Focused Review of Specific Remediation Issues

An Addendum to the Remediation System Evaluation
for the
Homestake Mining Company (Grants) Superfund Site, New Mexico

Final Report
December 23, 2010

Prepared by US Army Corps of Engineers
Environmental and Munitions Center of Expertise
For US Environmental Protection Agency, Region 6

Figure 15. Uranium Concentrations in Select Wells in a) Western Large Tailings Pile and b) Eastern Large Tailings Pile.

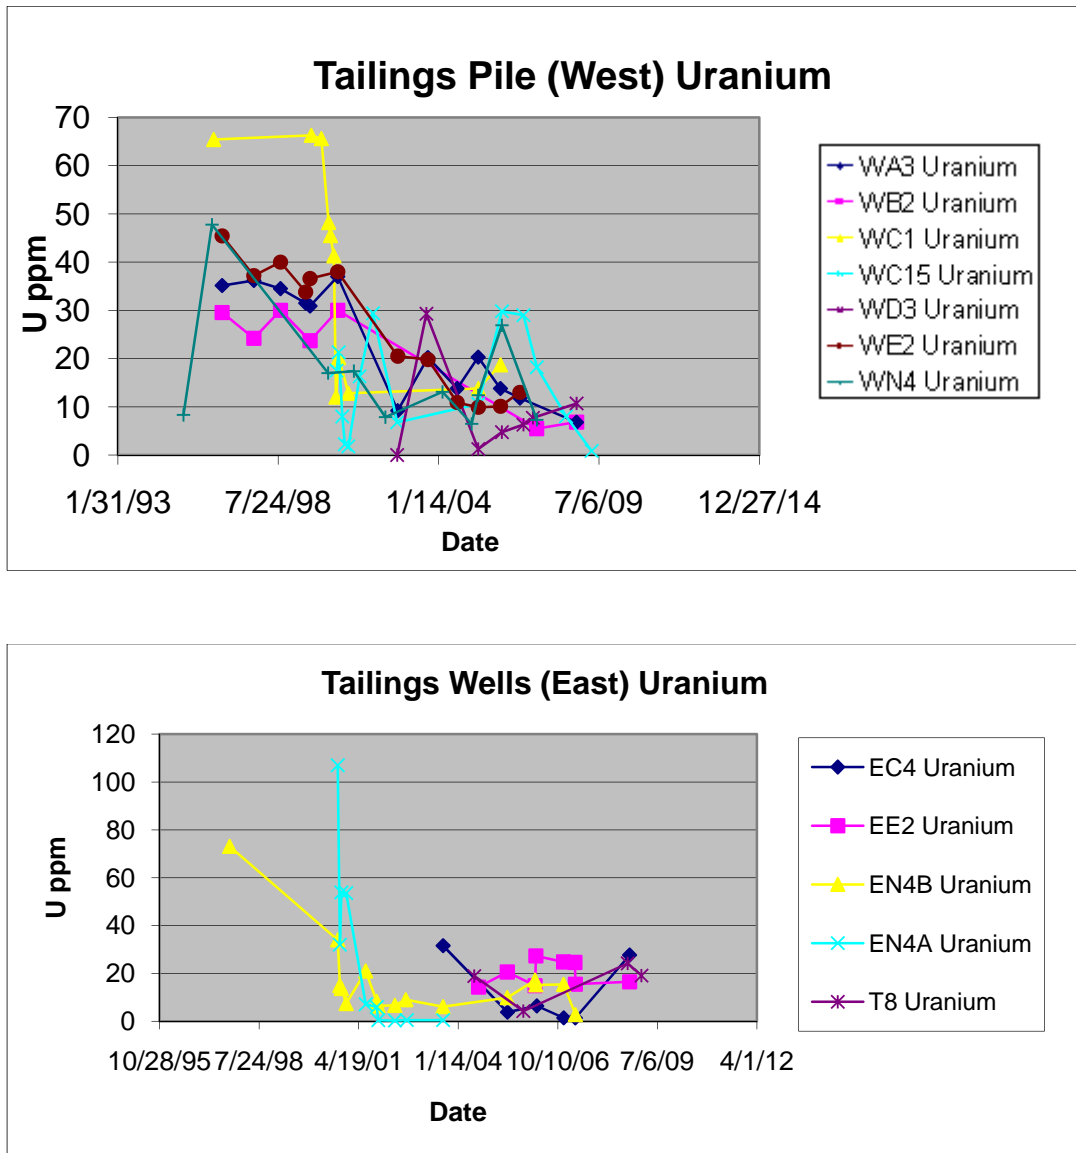
13. page 17, last paragraph, 3rd sentence. Change ‘has’ to ‘have’ and change figure to “Figure 15 in the same sentence.
14. page 18,. paragraph in the middle of the page regarding additional testing of oxidation-reduction potential. Please elaborate on the types of add’l testing that would be necessary and how the data should be interpreted.

57	NMED	4.1	18	Tailings in Figure 15 is misspelled.	Concur	Chart heading will be corrected.

Figure 21.

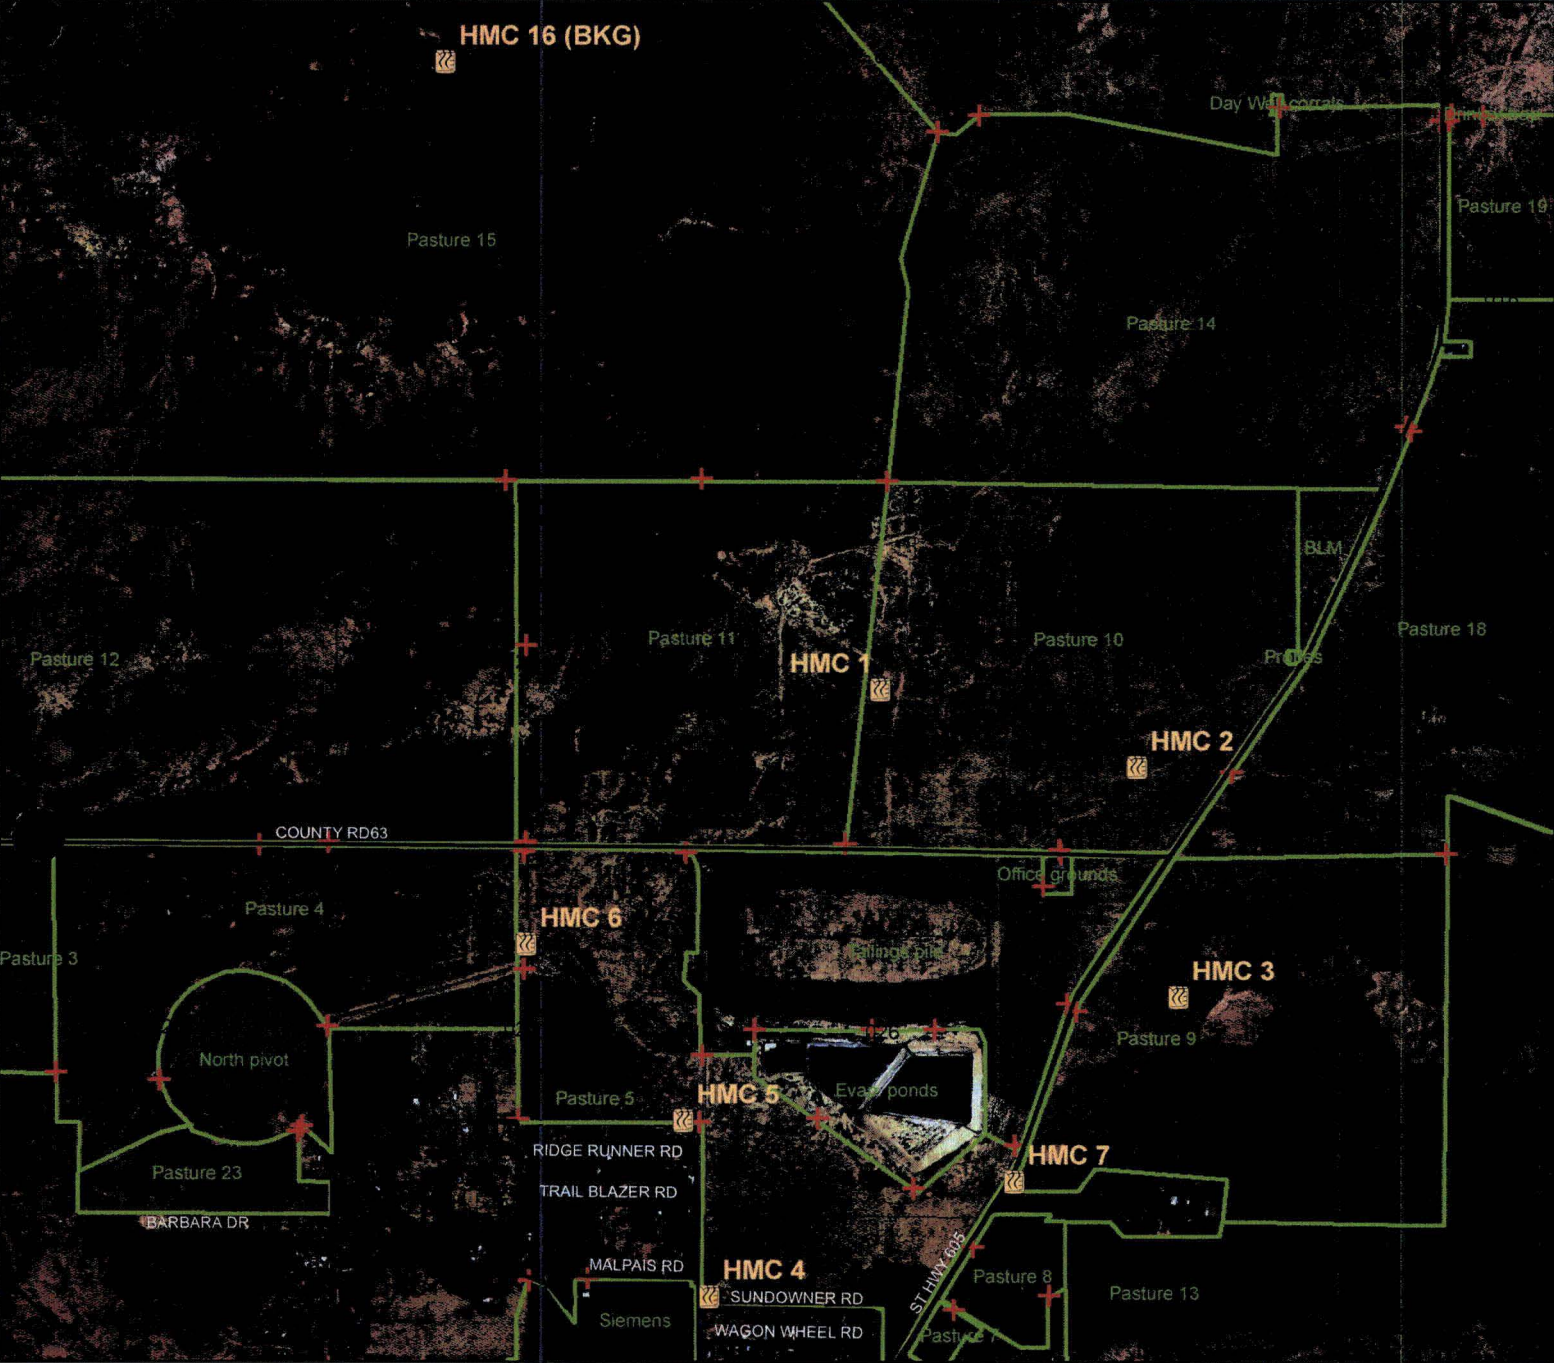
¹ DRSE Figure 21 is a copy of a map that HMC has used many reports for at least the last decade, but which is now known to be incorrect with respect to the location of HMC #16. The more recent figure that is reproduced as Figure 1 in this report not only is stated to be accurate with respect to the location of HMC #16 (see, testimony of Kenneth L. Baker, January 12, 2010 (HMC, 2010; Exhibit 36B)), but is also more legible.
